JULY 9, 2025

CONTRACT NO. 1800

WET WEATHER PUMP STATION

ADDENDUM NO. 3

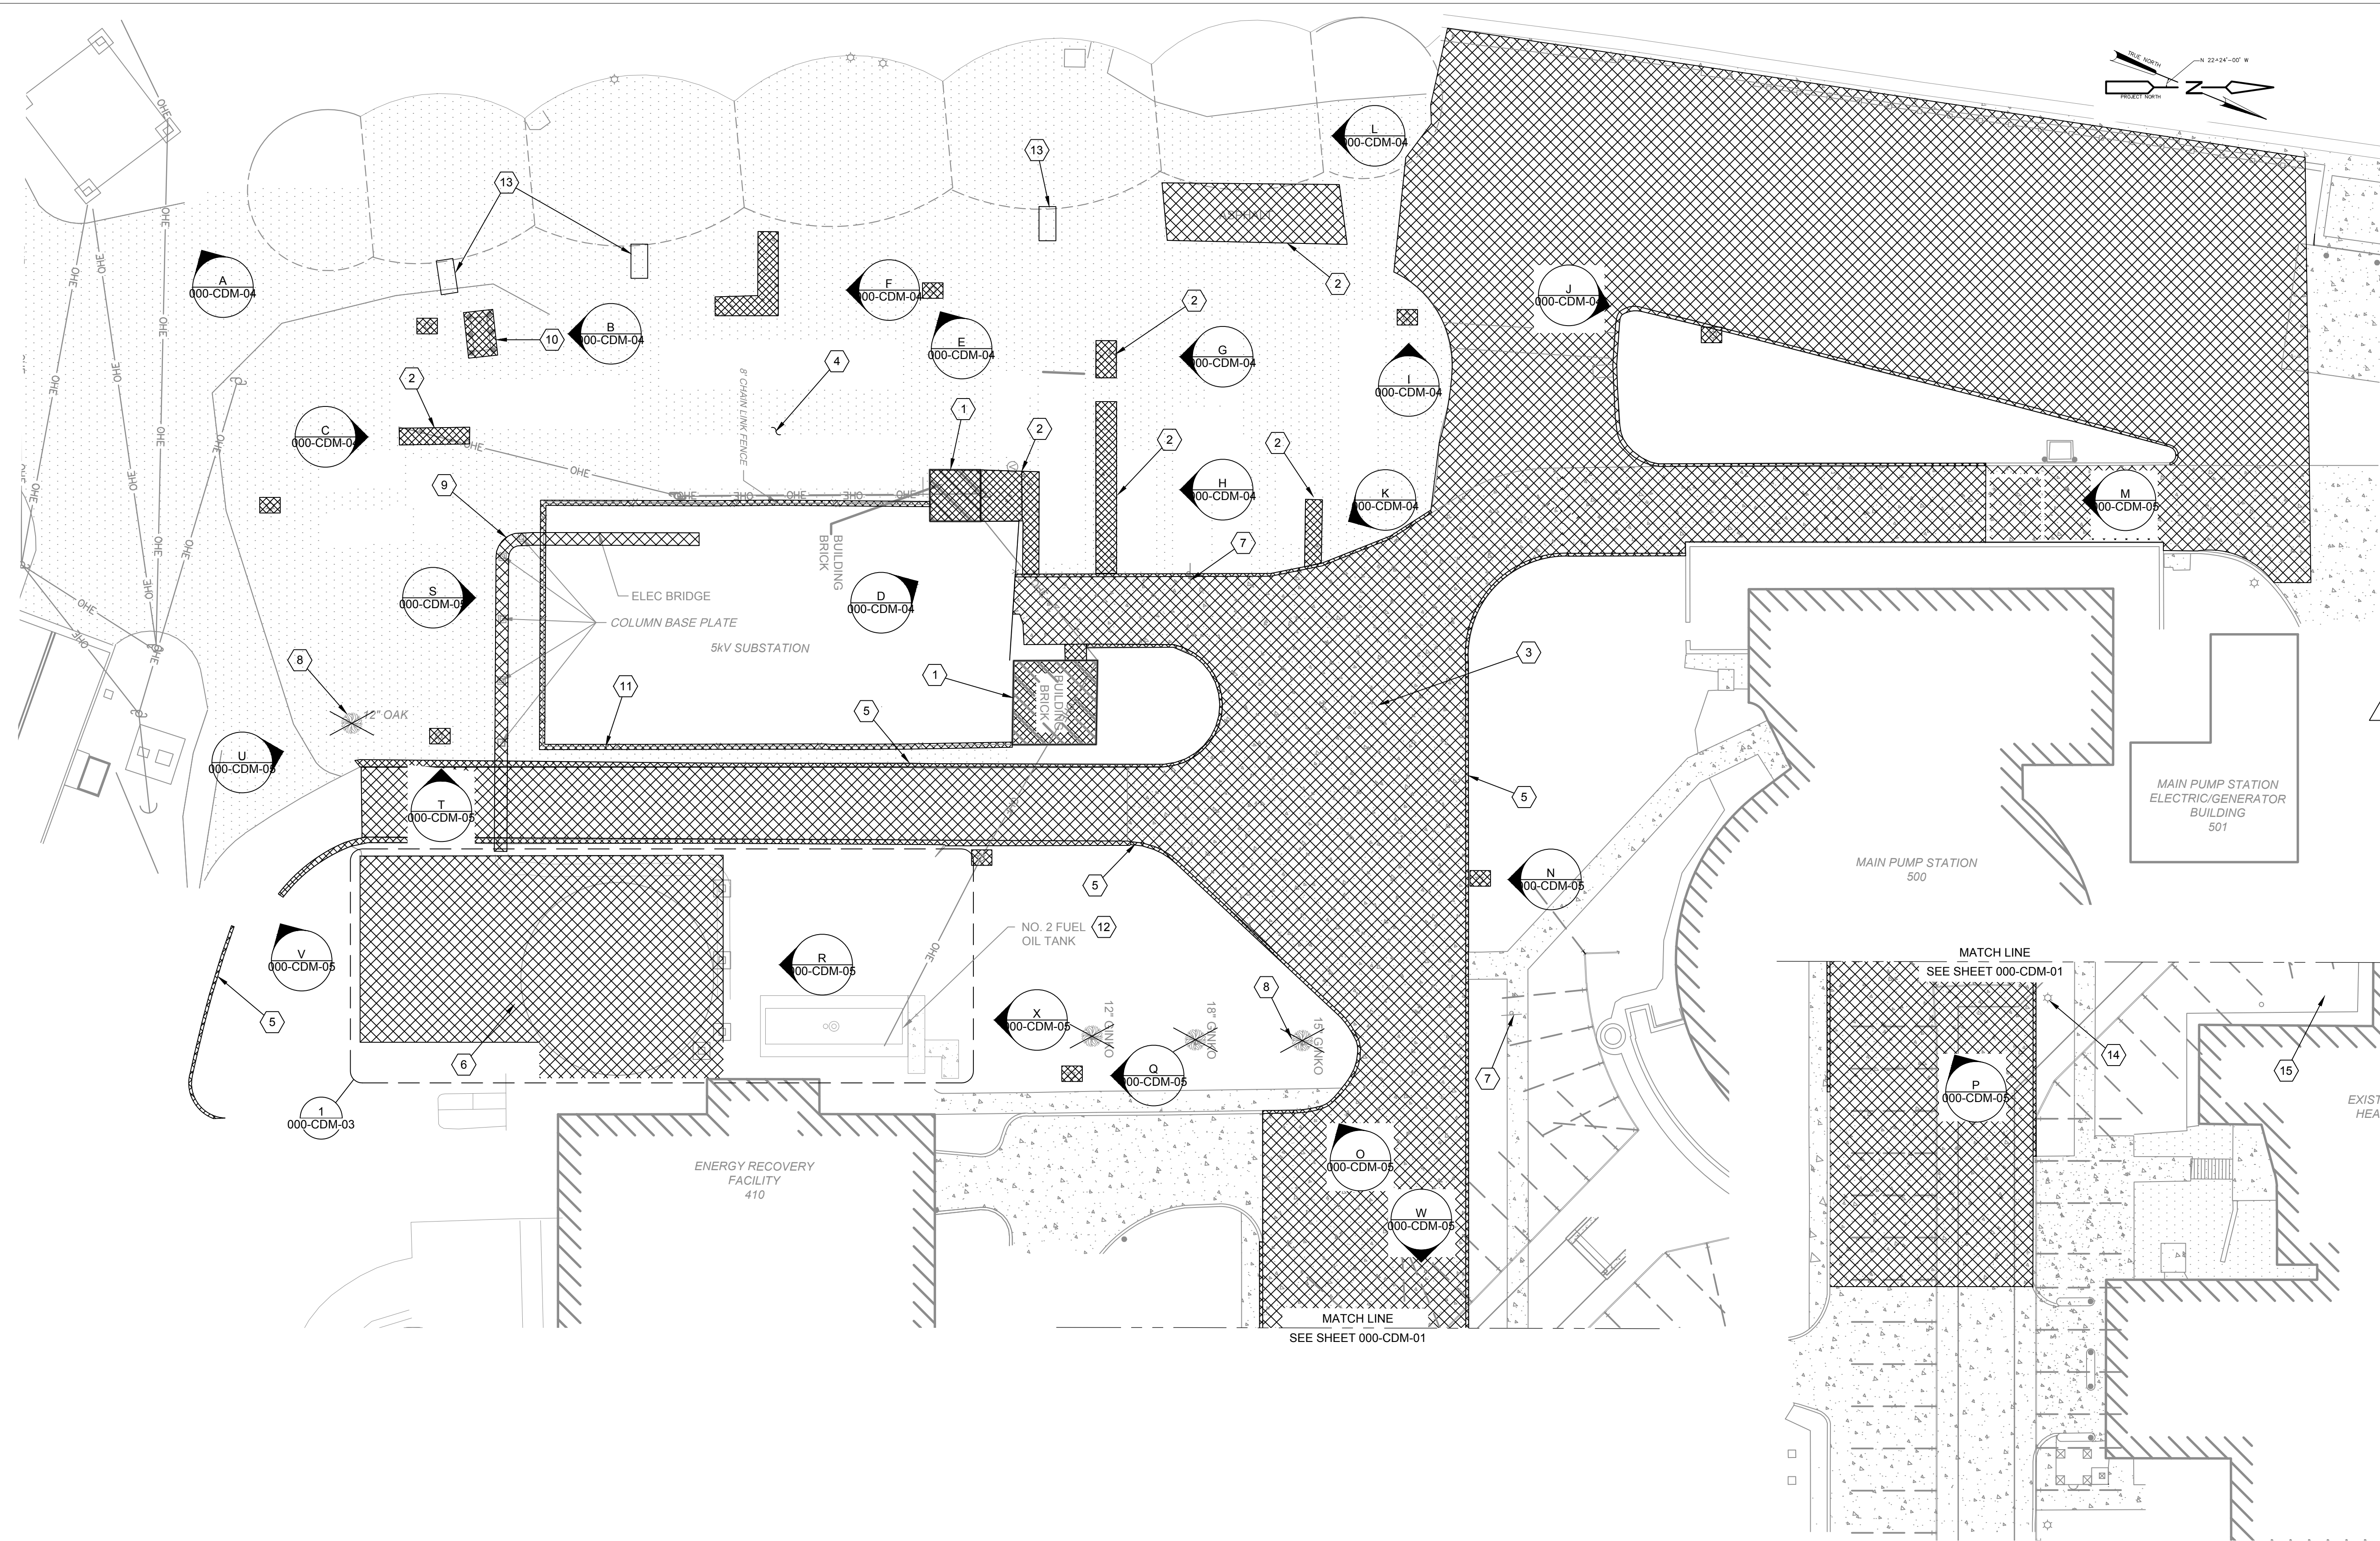
Q16: Sheet 000-CDM-01, keynote 13 of the Site Demolition Plan calls for three Test Pits along the river wall. What is the estimated depth of the test pits. As a reference the depth of the Test Pits referred to in the Contract Documents Volume 5 of 5 was 10 feet.

A16: Drawing 000-CDM-01 has been revised to clarify the requirements. Refer to Item 2.1 in Addendum No. 3.

000-CDM-03 FUEL CONTAINMENT AREA DEMOLITION PLAN

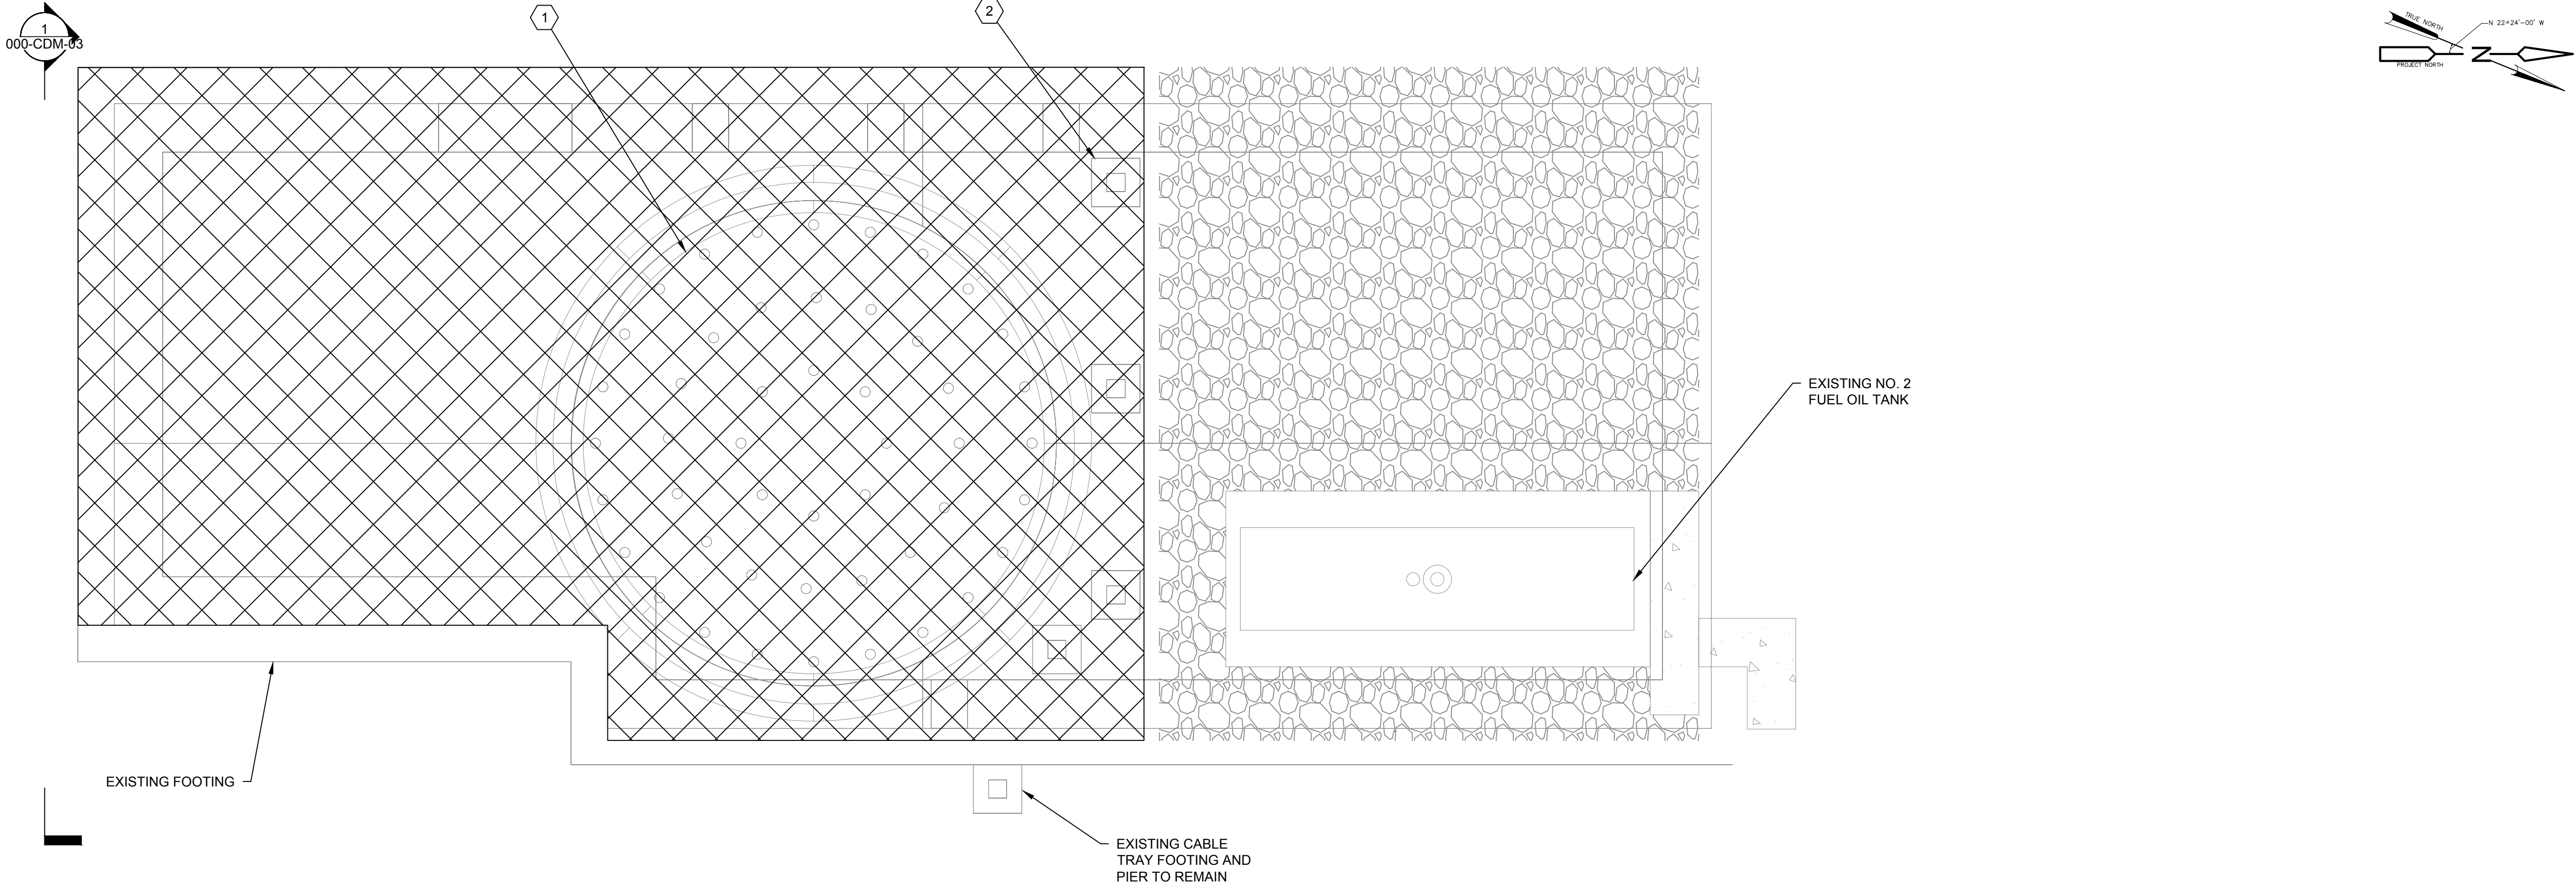
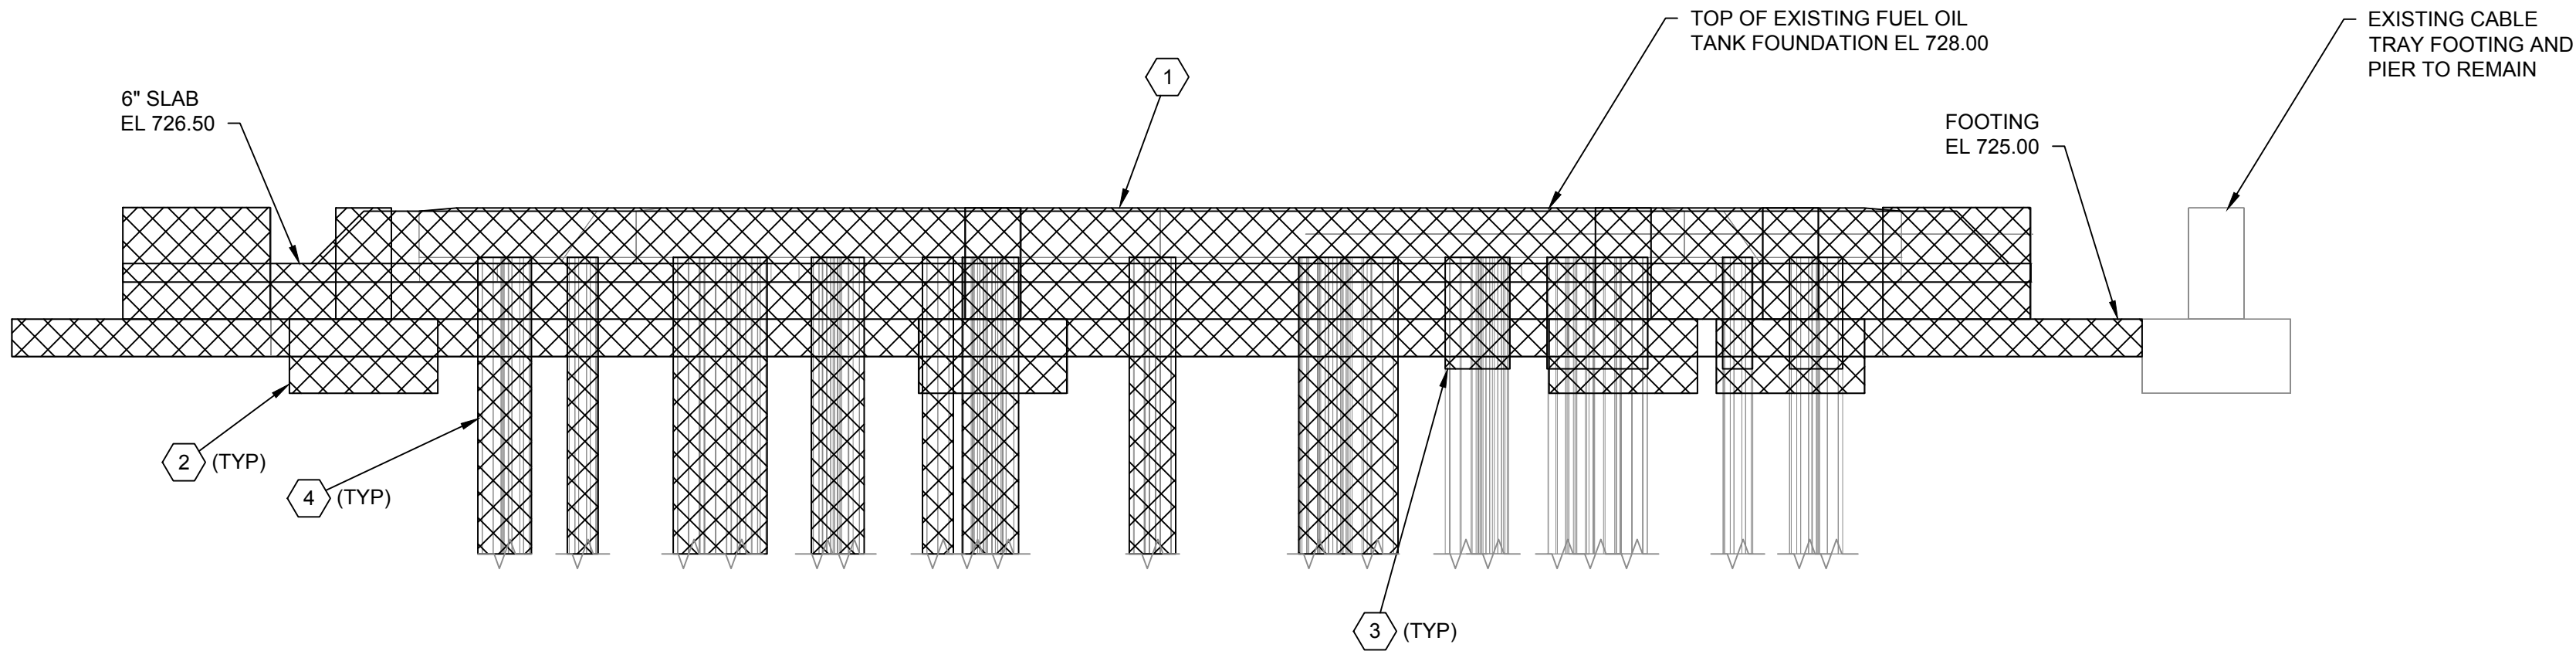
- 2.1 On Sheet 000-CDM-01, **UPDATE** keynotes. **REPLACE** Sheet 000-CDM-01 with Sheet 000-CDM-01 Rev. 01, refer to Attachment A.
- 2.2 On Sheet 000-CDM-03, **UPDATE** keynotes. **REPLACE** Sheet 000-CDM-03 with Sheet 000-CDM-03 Rev. 01, refer to Attachment A.
- 2.3 On Sheet 000-C-04, **UPDATE** information on existing trailers. **REPLACE** Sheet 000-C-04 with Sheet 000-C-04 Rev. 01, refer to Attachment A.

Q15: Contract drawing 000-CDM-03 shows the Fuel Containment Area Demolition Plan. What is the type and length of pile under the fuel containment foundation?

A15: Pile type and length is provided in Volume 1 of 1 Reference Information, Section 5B. Drawing 000-CDM-03 has been revised to clarify the requirements. Refer to Item 2.2 in Addendum No. 3.

- DEMOLISH TANK FOUNDATION, FOOTINGS AND 6" SLAB.
- DEMOLISH EXISTING CABLE TRAY (NOT SHOWN), FOOTINGS, PIER AND STRUCTURE.
- CUTOFF EXISTING PILES IN PLACE A MIN 3' BELOW GRADE, WHERE PILES DO NOT INTERFERE WITH UTILITIES.
- PILES LOCATED BELOW PROPOSED UTILITIES SHALL BE REMOVED OR CUTOFF 3' BELOW THE PROPOSED UTILITIES INVERTS. PROVIDE BACKFILL MATERIAL PER SECTION 31 21 00 PART 2.01.F WITHIN THE VOIDS LEFT BY REMOVAL/DEMOLITION OF THE PILES.

Designed by:	REVISION			
	REV No.	DATE	DESCRIPTION	APPV
D.SIGLER	0	5/16/25	ISSUED FOR BID	DS
Drawn by:	1	6/26/25	ADD. 3 PILE BACKFILL REQUIREMENTS	DS
D.SIGLER				
Checked by:				
S.LOCKHART
